Appendix B

Agency Coordination Letters

**RE: Interstate 10, Ina Road TI to Ruthrauff Road TI DCR and EA
ADOT Tracs No. 010 PM 247.0 H7583 01L**

Re: I-10 Ina Road Traffic Interchange (TI) to Ruthrauff Road TI Design Concept Report (DCR) and Environmental Assessment

Figure 3. Section 4(f) resources

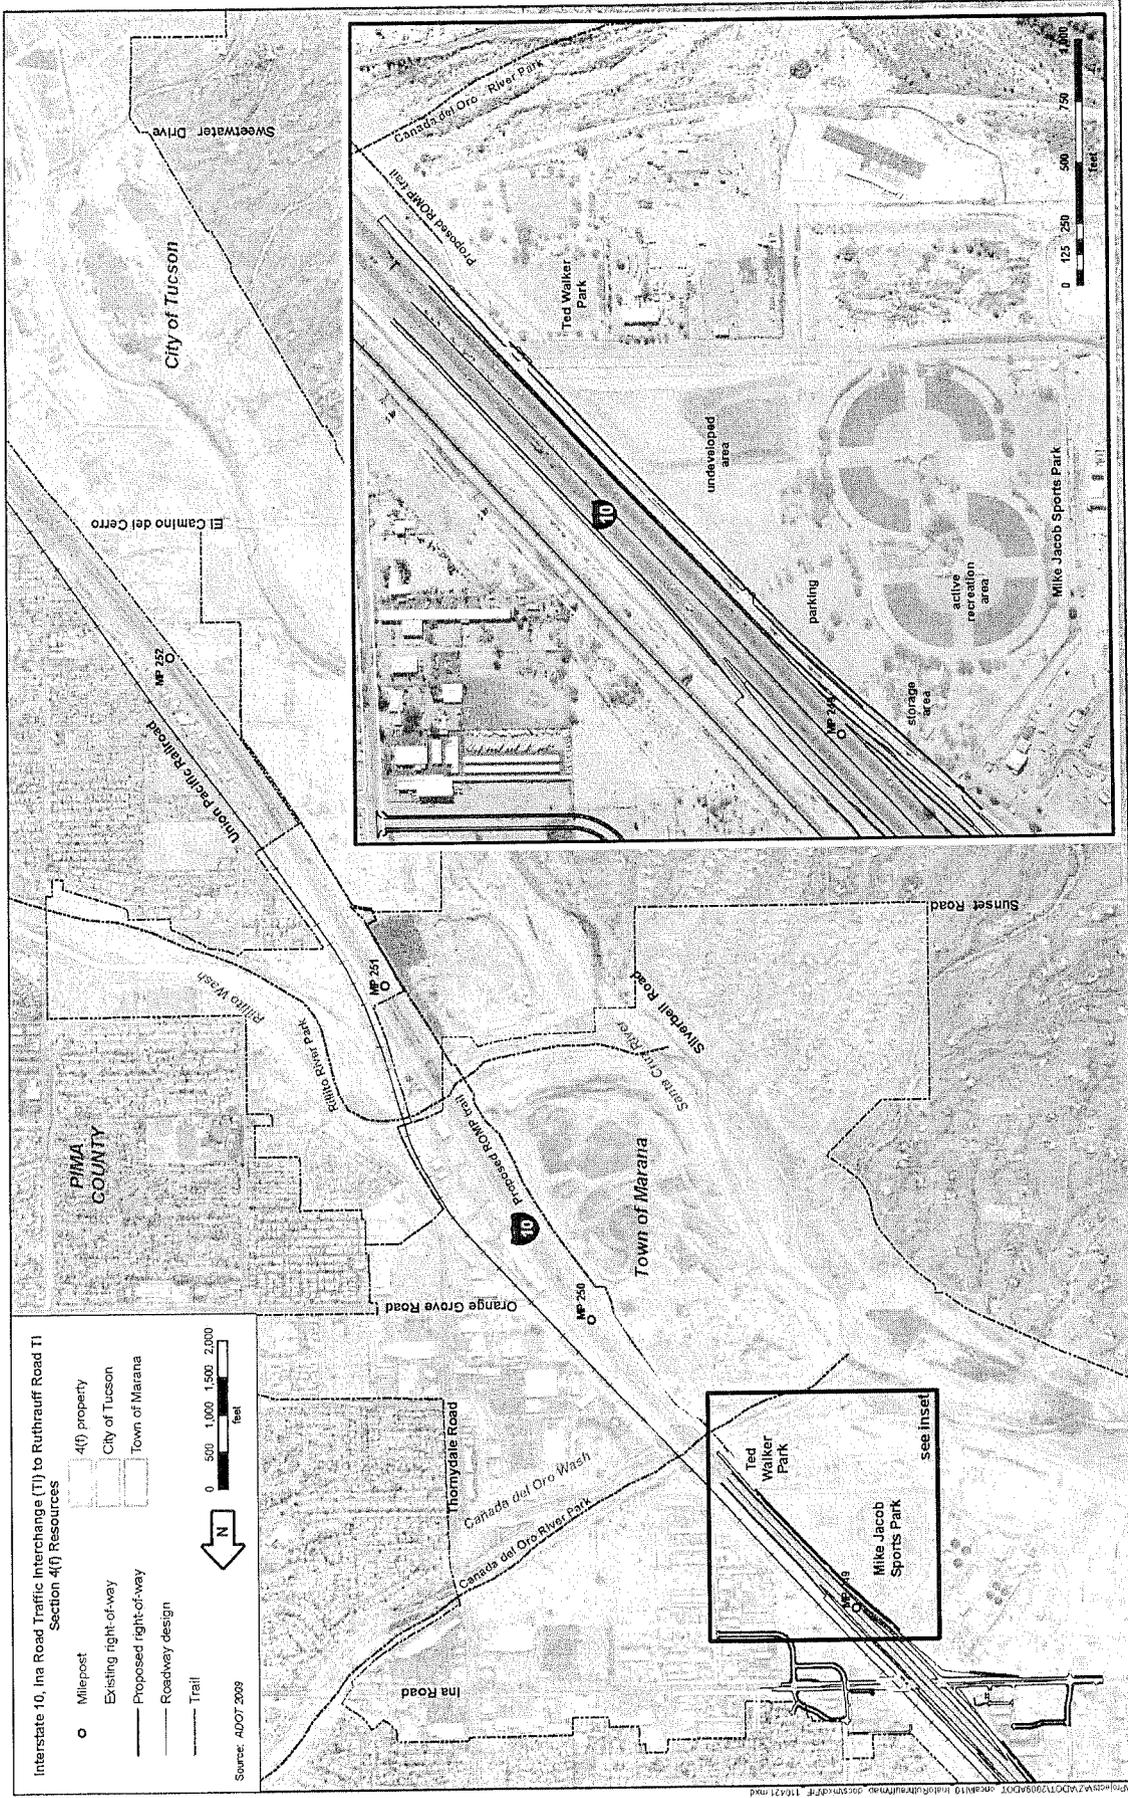
Pima County-managed Section 4(f) resources identified within the project area are as follows: Mike Jacob Sports Park, Ted Walker Park, Cañada del Oro River Park, Rillito River Park, and Pima County's Regional Optimization Master Plan (ROMP) trail. Refer to Figure 3 for the locations of the evaluated properties in relation to the project area. These facilities are considered Section 4(f) properties because they are parks or recreation areas on public lands that are available for public use. These properties have been evaluated for impacts caused by the proposed transportation improvements. This evaluation has determined that the proposed project would not adversely affect the activities, features, and attributes of the properties. Each of these properties is discussed individually below.

Properties protected under Section 4(f) within the project area would not be adversely affected by the proposed project. Approximately 3 percent of the Mike Jacob Sports Park would be incorporated into a transportation facility, resulting in "use" of the Section 4(f) resource; however, impacts to attributes qualifying the park for protection would be limited to the removal of parking spaces and landscaping. ADOT would coordinate with Pima County to replace lost parking areas and landscaping on-site, as well as maintaining access to the park during construction. If the project requires relocation of the ROMP pipeline, the associated access road and trail would also be relocated, thus maintaining continuity of the public resource.
